Dated May 17, 2021

Contractor Questions:

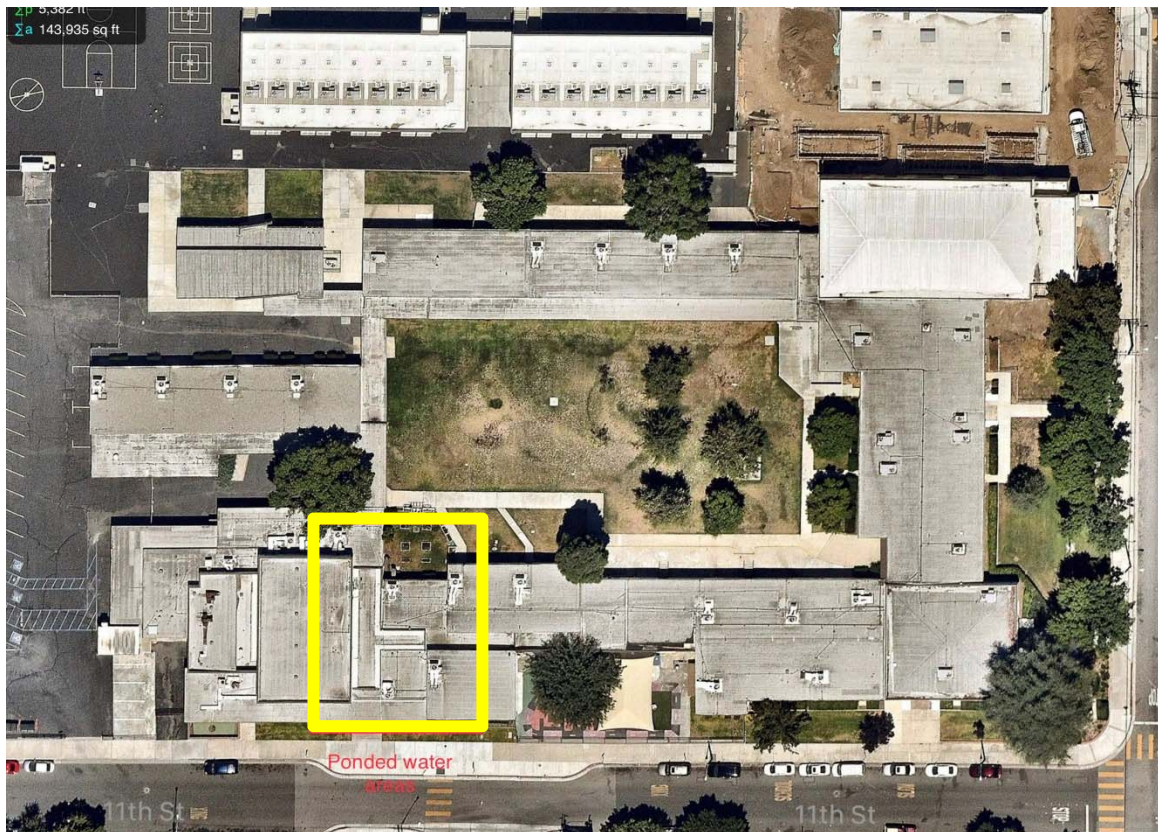
Q1. Identify ponding areas for taper/cricket system.

A1. Minimize ponding water in the areas marked in the photo below. When finished ponded water must be dry within 48 hours.
